TMI-1 Technical Specification Change Request No. 279 Safety Evaluation

I. Technical Specification Change Request No. 279

II. Reason for Change

Figure 1
TMI-1 Core Protection Safety Limit

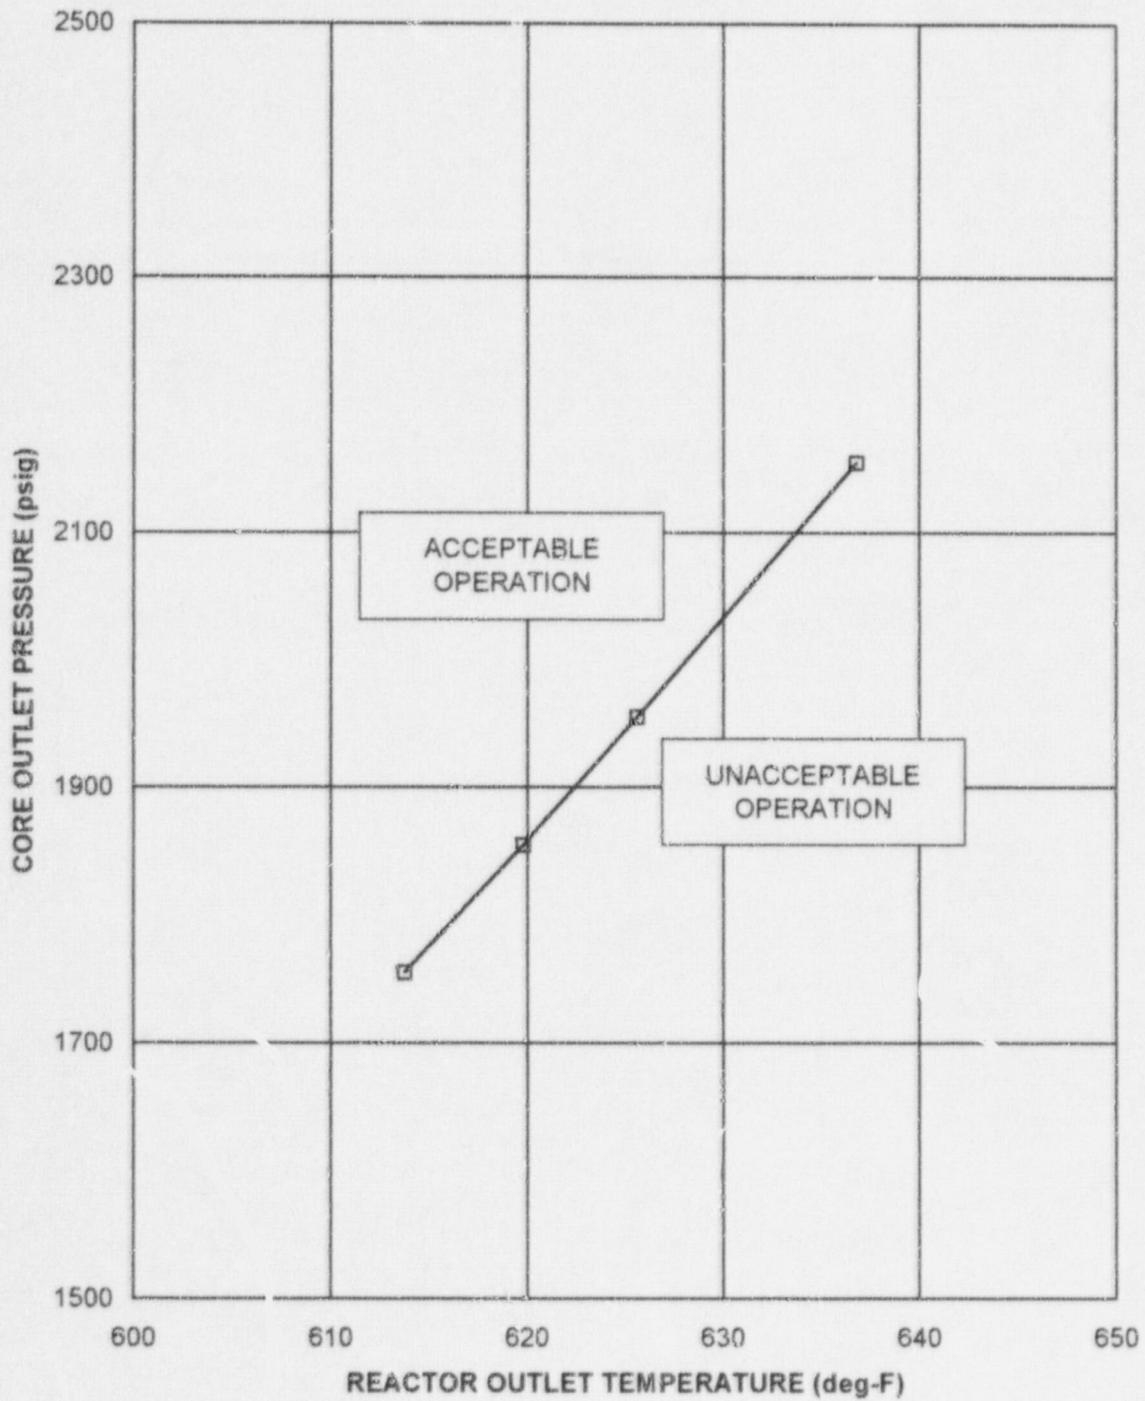
The purpose of this Technical Specification Change Request (TSCR) is to revise the TMI-1 Core Protection Safety Limits and Core Protection Safety Bases, as specified on Technical Specification Figures 2.1-1 and 2.1-3, to provide more restrictive limits which reflect the decrease in reactor coolant system flow resulting from the analysis of increased once-through steam generator (OTSG) tube plugging limits.

The core protection safety limit (T.S. Figure 2.1-1) and bases (T.S. Figure 2.1-3) define the region of unacceptable operation when the conditions of the RCS approach the DNB limit. The safety criteria in determining these limits are entirely based on DNB protection. The applicable BWC CHF correlation DNB limit for TMI-1 is 1.18 or a coolant quality limit of 26%. Currently, the P-T RPS trip setpoints in T.S. Figure 2.3-1 are more restrictive than the variable low pressure (VLP) setpoints, which are derived from the core protection safety limit. This is because the VLP setpoints are outside the box established by the pressure-temperature RPS trip setpoints.

The core protection safety limits were re-analyzed with 20% SGTP based on the reduced minimum RCS design flow (102% from 106.5% of 352000 gpm). A series of VIPRE hot channel analyses were performed by varying RCS flow, inlet temperature and system pressure (GPU Nuclear Calculation C-1101-202-E620-365). The DNB analysis for each particular pump condition was performed and results are given in attached Figure 1 (new core protection safety limit) and Figure 2 (core protection safety bases) which correspond to the proposed revised TMI-1 Technical Specification Figures 2.1-1 and 2.1-3. These results are also compared against the existing safety limits and bases in T.S. Figures 2.1-1 and 2.1-3. The comparison is shown on Figure 3, which shows that the 20% SGTP limit results in a slightly more restrictive safety limit. In Figure 4, the VLP setpoints are overlaid with the TMI-1 protection system maximum allowable setpoints (T.S. Figure 2.3-1). As can be seen from this figure, the existing P-T setpoints bound the VLP setpoints. Consequently, the P-T trip setpoints in T.S. Figure 2.3-1 are still applicable with 20% SGTP limit.

Figure 3
TMI-1 Core Protection Safety Limit Comparison
(With 20% Average OTSG Tube Plugging)

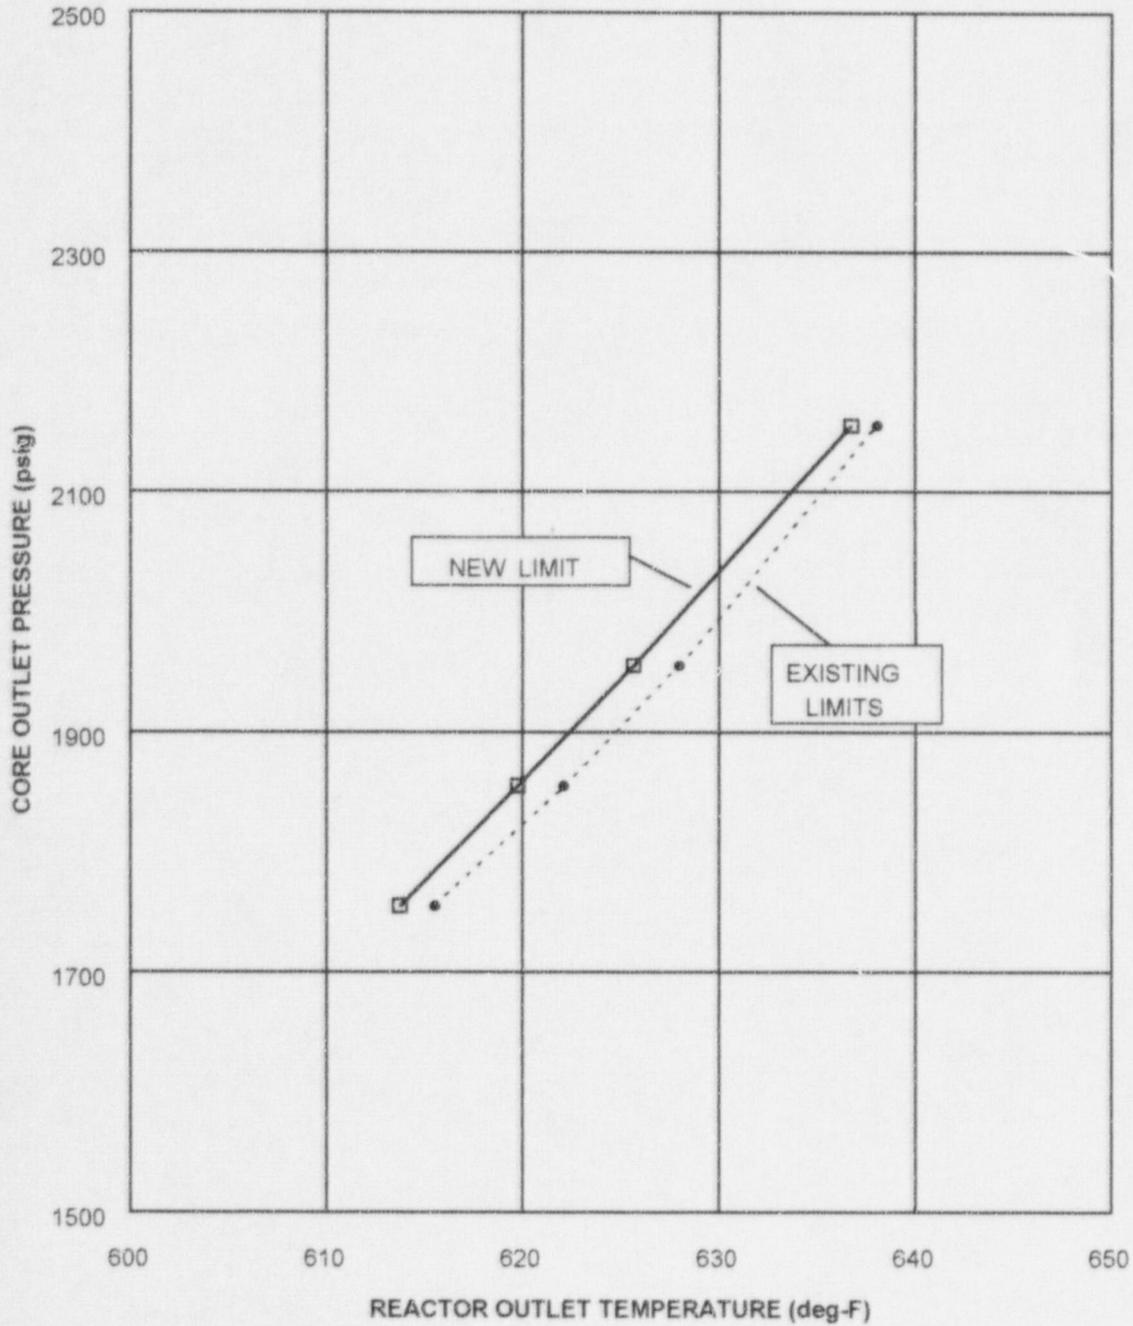
The TMI-1 Technical Specifications (T.S.) contain the RPS trip setpoints in T.S. Table 2.3-1, including the core P-T trip setpoints in T.S. Figure 2.3-1. The Technical Specifications also contain the core protection safety limit (T.S. Figure 2.1-1) and corresponding safety bases (T.S. Figure 2.1-3). The impacts of the 20% SGTP on these setpoints and limits were evaluated and reanalyzed. The results show that all the current RPS trip setpoints are still applicable while the core protection safety limit and its bases given in T.S. Figures 2.1-1 and 2.1-3 become slightly more restrictive than those in the current T.S.

Figure 4
Protection System Maximum Allowable Setpoints
(With 20% Average OTSG Plugging)

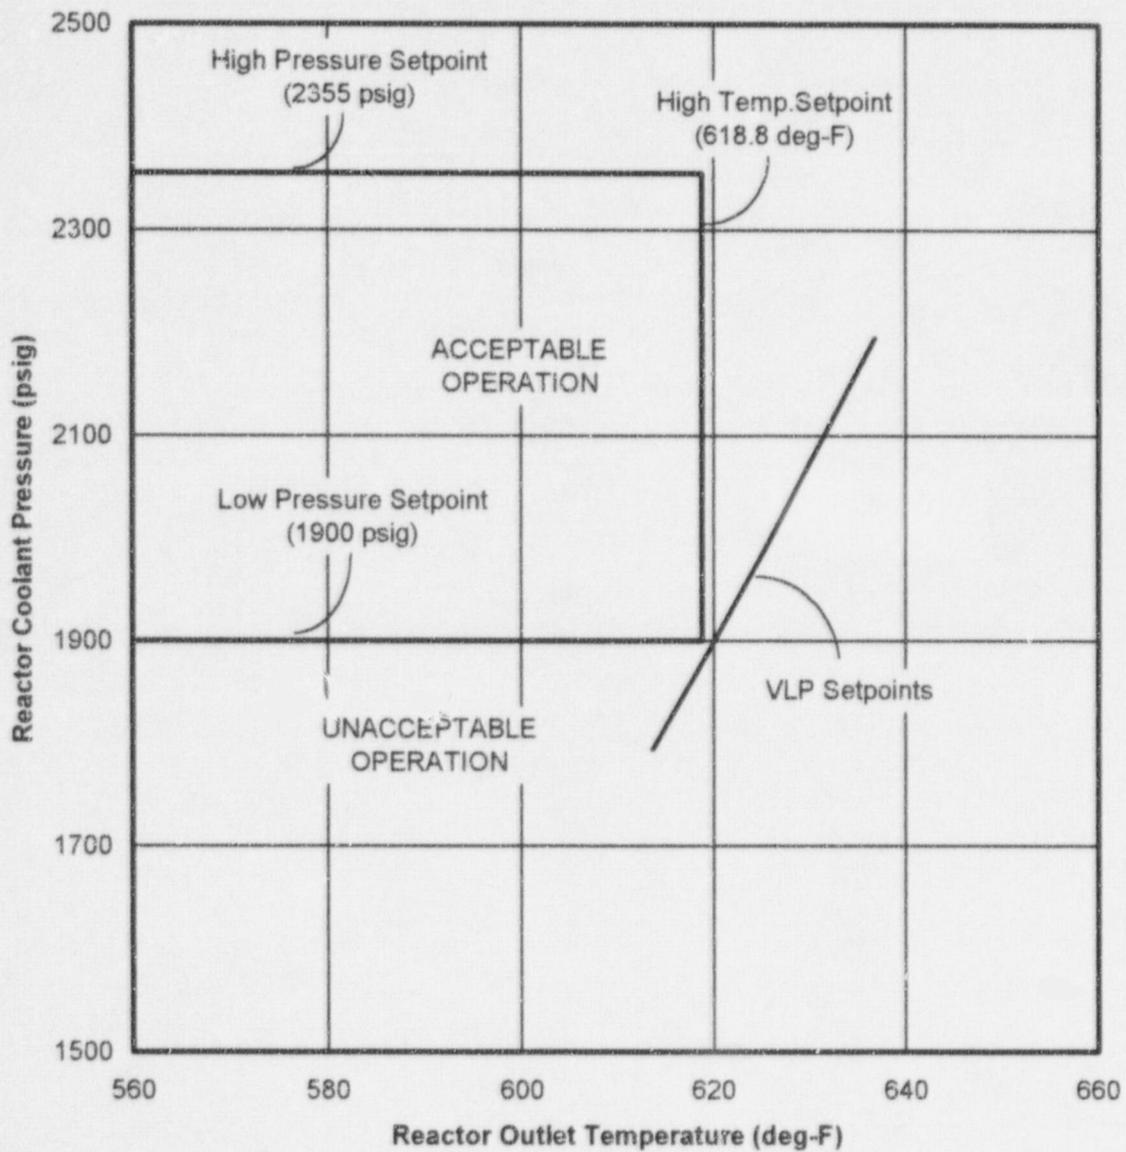
reactor protection system (RPS) maximum allowable setpoints, which are formed by the low pressure, high pressure, and high temperature trip setpoints. These setpoints are currently more restrictive than the setpoints based on the limits established by Figure 2.1-1. For 20% steam generator tube plugging (SGTP), the proposed revised limits of Figures 2.1-1 and 2.1-3 are more restrictive. However, they remain bounded by the current RPS trip setpoints of Figure 2.3-1, as described below.
